Ref: FCC Class II Permissive change for FCC ID: HCQ3B6PORUNV

Applicant: Inovonics Wireless Corporation

This is to request a Class II permissive change for FCC ID: HCQ3B6PORUNV , originally granted on 08/31/2006

layout:

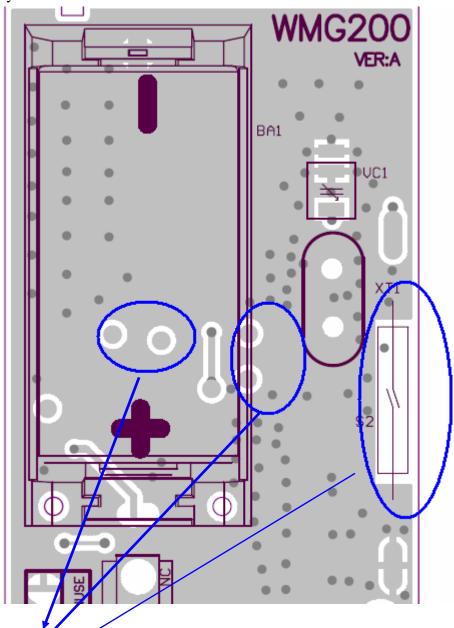
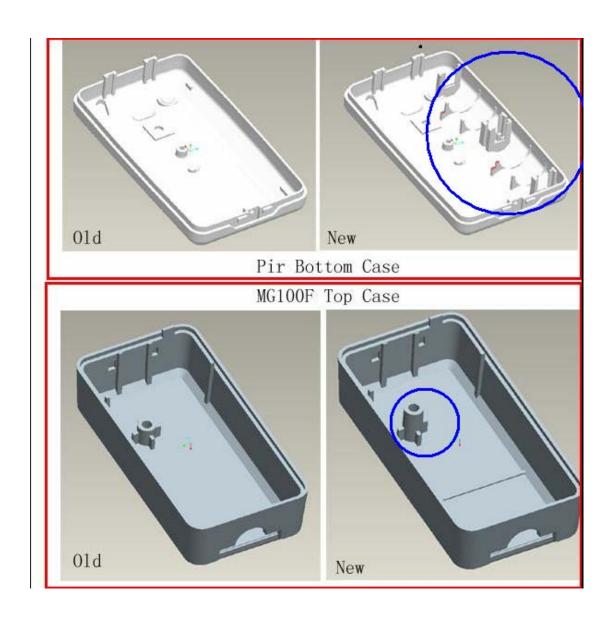
- 1. C17 capacitance change to 9P from 3P;
- 2. C9 capacitance change to 11P from 3p;
- 3. C10 capacitance change to 6P from 5P;
- 4. VC1(adjuster of capacitor) change to 3-6P from 3-10P;
- 5. add L1(inductance) 22NH

- 6. add test position for battery
- 7. change to SMD from DIP
- 8. layout has been changed
- 9. Externals:(as below)
